COUNCIL REPORT

DATE: May 14, 2024
CATEGORY: Consent
DEPT.: Community Development
TITLE: **Public Art for Evelyn Park, Project 21-60**

Approve the revised Looking Up Arts' monarch butterfly sculpture entitled "Butterfly Reflect" for Evelyn Park, Project 21-60, for \$30,000.

Figure 3: Revised Butterfly Reflection by Looking Up Arts

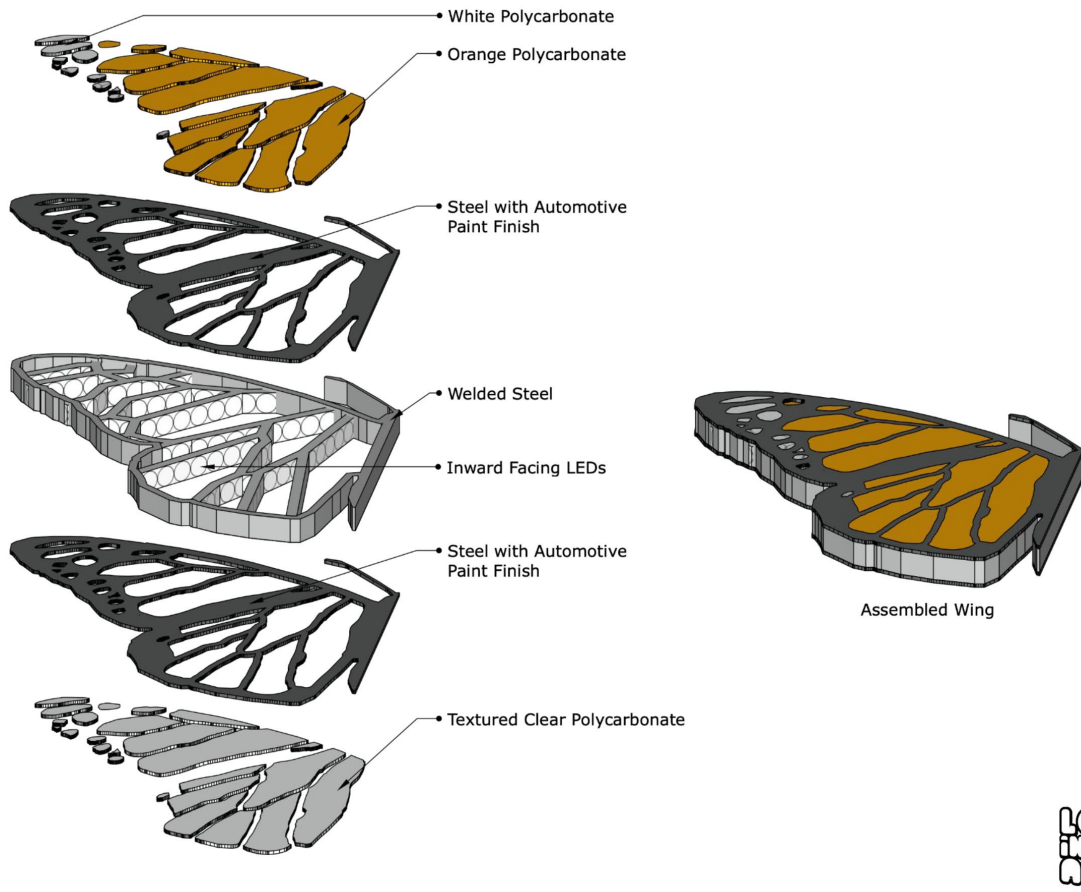
On [February 27, 2024](#), the City Council discussed the VAC-recommended “Butterfly Reflect” art for Evelyn Park and referred the item back to the VAC to address concerns about the LED lighting and the implications for the preservation of dark skies as well as the park-goer experience related to the underside of the butterflies. (The City Council Strategic Work Plan currently includes a project to develop a Dark Skies Ordinance.)

1. What should the park-goer experience look and feel like at ground level, underneath the butterflies? What elements of the piece can be improved at ground level?
2. Should lighting be incorporated into the piece? What does the piece look like with reduced lighting or no lighting?

The Looking Up Arts artist team shared a revised sculpture concept based upon Council's feedback (see Attachment 3). The revised concept (shown in Figure 3) includes the following changes:

1. Tinted top panels (polycarbonate) will allow natural light to come through the top of the butterflies during the day and limit upward LED light transmission at night.
2. Rather than using an LED panel display, LED lights will be affixed internally to the butterfly wings which will illuminate the butterflies from within.
3. The removal of the LED panel results in a 75% reduction in the LED light count and overall brightness. Each butterfly will produce less than 100W.
4. Updates to controller software will allow for remote adjustments to colors, patterns, brightness, and scheduling.

5. The top and bottom polycarbonate panels will allow for a unique viewing experience from a distance and from below.

Figure 3: Evelyn Park—Location No. 1

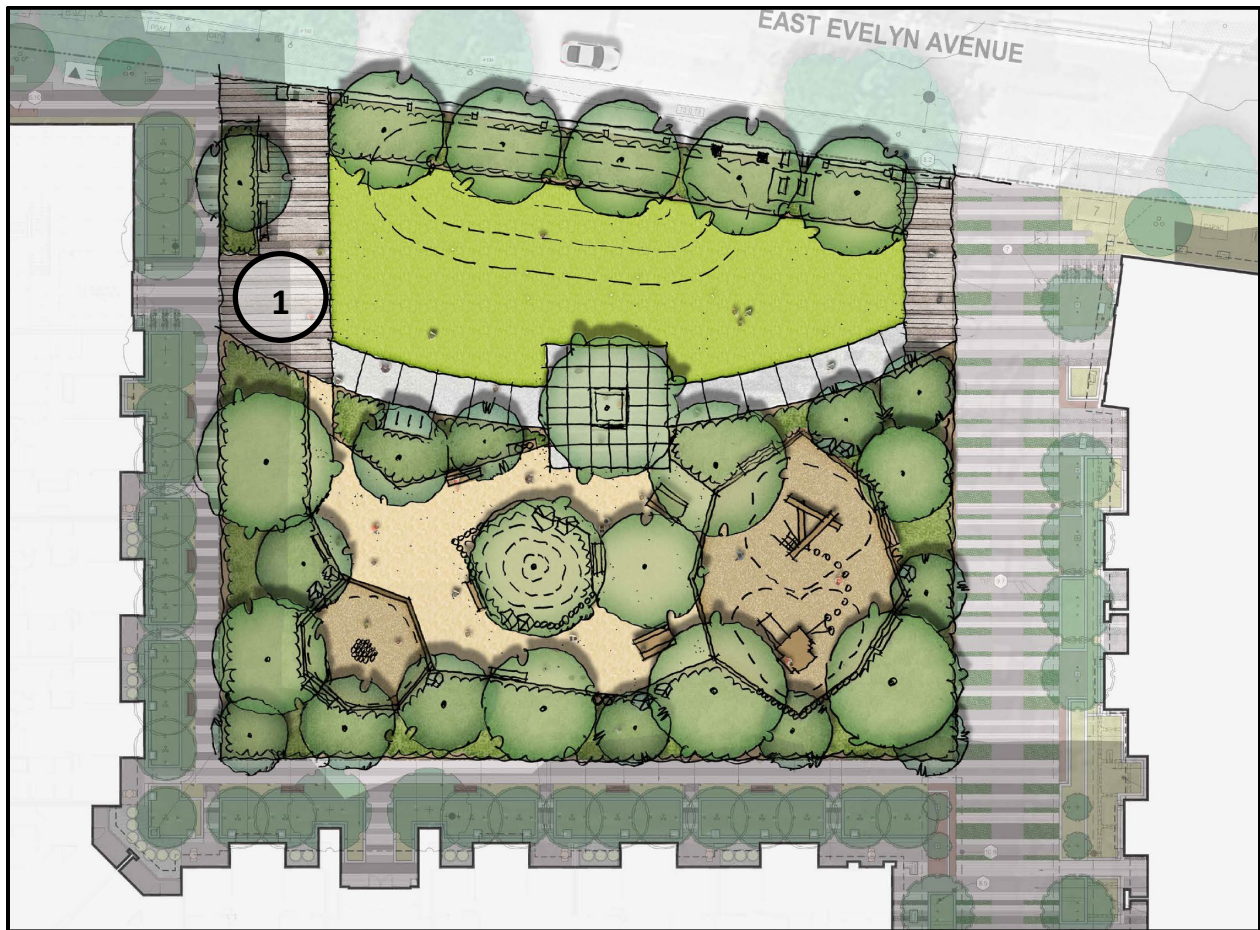
For the ground-level experience and activation of the walkway, Public Works project staff indicated that the art would need to be placed within the plaza at Evelyn Park (Location No. 1 in Figure 3), and to maintain consistency throughout the plaza, pavers will need to be placed around the concrete base of the art. Looking Up Arts will work with staff to determine feasibility to customize the pavers with butterfly outlines underneath the art to further enhance the ground-level user experience and stay within the project budget and timeline.

At their April 10, 2024 meeting, the VAC recommended that the City Council approve the revised sculpture, “Butterfly Reflect,” by Looking Up Arts, allow the LED lighting to remain on between 6:00 a.m. and 11:00 p.m., and permit the artist team to pursue the stamping of the pavers if it fits within the project budget.
